RELEVANT INFORMATION FOR COUNCIL

FILE: D/2016/1754 **DATE:** 12 May 2017
TO: Lord Mayor and Councillors
FROM: Graham Jahn, Director City Planning, Development and Transport
SUBJECT: Information Relevant To Item 8.8 - Development Application - 1-5
Wentworth Street Glebe - At Council - 15 May 2017

Figure 1: Typical floor plan of northeast corner apartment

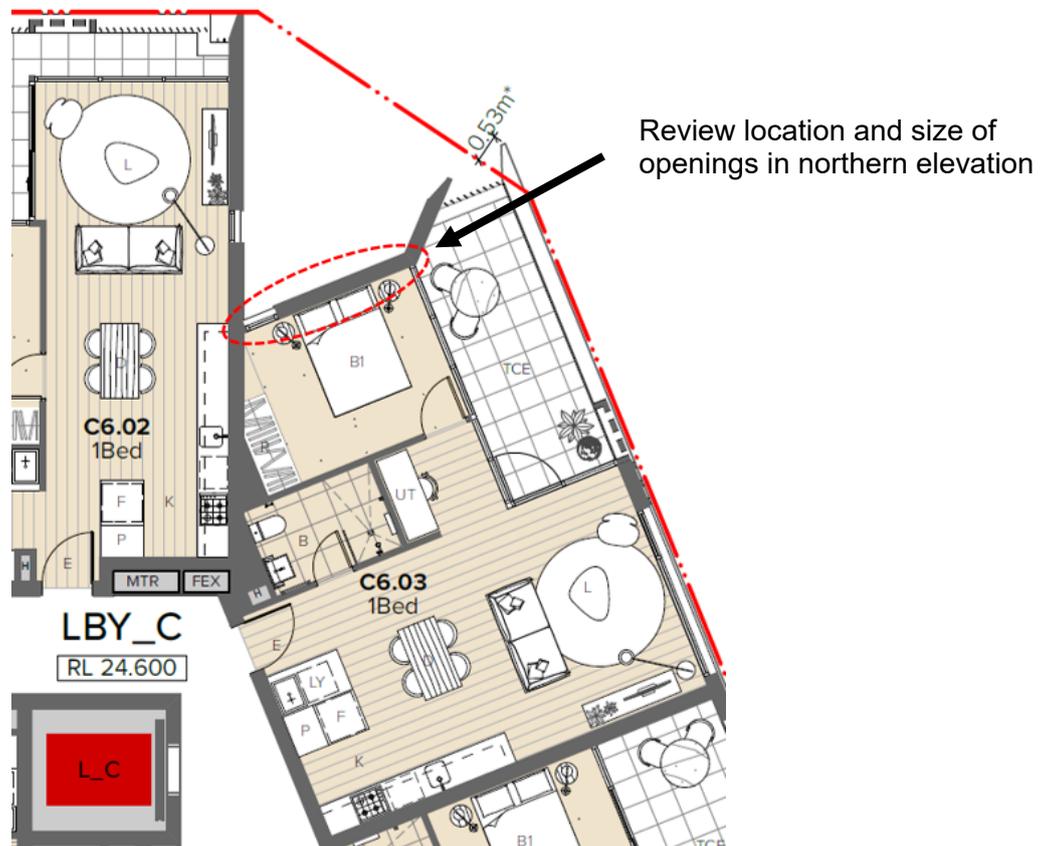
1. Opportunity to improve the amenity and/or outlook of the northeast corner units.
2. Opportunity for greater provision of usable and soft landscaped area on the roof top communal open space, including any opportunity for a green wall or similar.

Following a meeting with the applicant's architect, a number of options were discussed to potentially improve the outlook and amenity of the north-east corner apartments. An additional design modification condition has been recommended for imposition, requiring consideration be given to the proposed size and location of the openings along the northern elevation of the north-east corner apartments.

- (b) ***Amend the window location and size on the northern elevation of dwellings C1.03, C2.03, C3.03, C4.03, C5.03, C6.03 and C7.03 so as to improve the outlook of those dwellings.***

Figure 2: Proposed landscaping plan for roof top communal open space

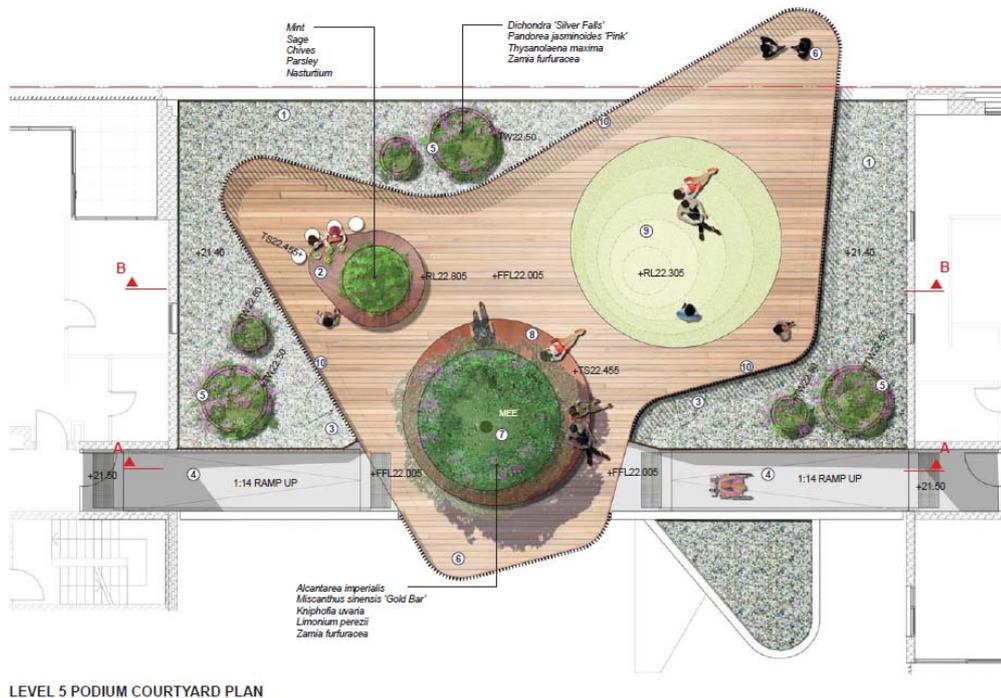
There are a number of options in which the Level 5 communal open space could be reconfigured to increase the quantity of planting, as well as useable space for the recreation and social interaction of the residents.

Whilst a green wall would be possible, in this instance, given that the proposed development consists of affordable housing, a structural green wall is not recommended due to the initial cost implications and the ongoing maintenance requirements. However, appropriately selected climbing plants would be possible on the east and west elevations either side of this roof terrace to provide a similar effect if desired.

The design modification condition has been amended to require a redesign of the roof top communal open space to increase the extent of soft landscaping and provide more facilities that encourage social interaction.

The design of the proposed roof top communal open space on Level 5 is not approved and must be redesigned to include additional soft landscaping and provide facilities that encourage social interaction and recreation opportunities for the building's occupants.
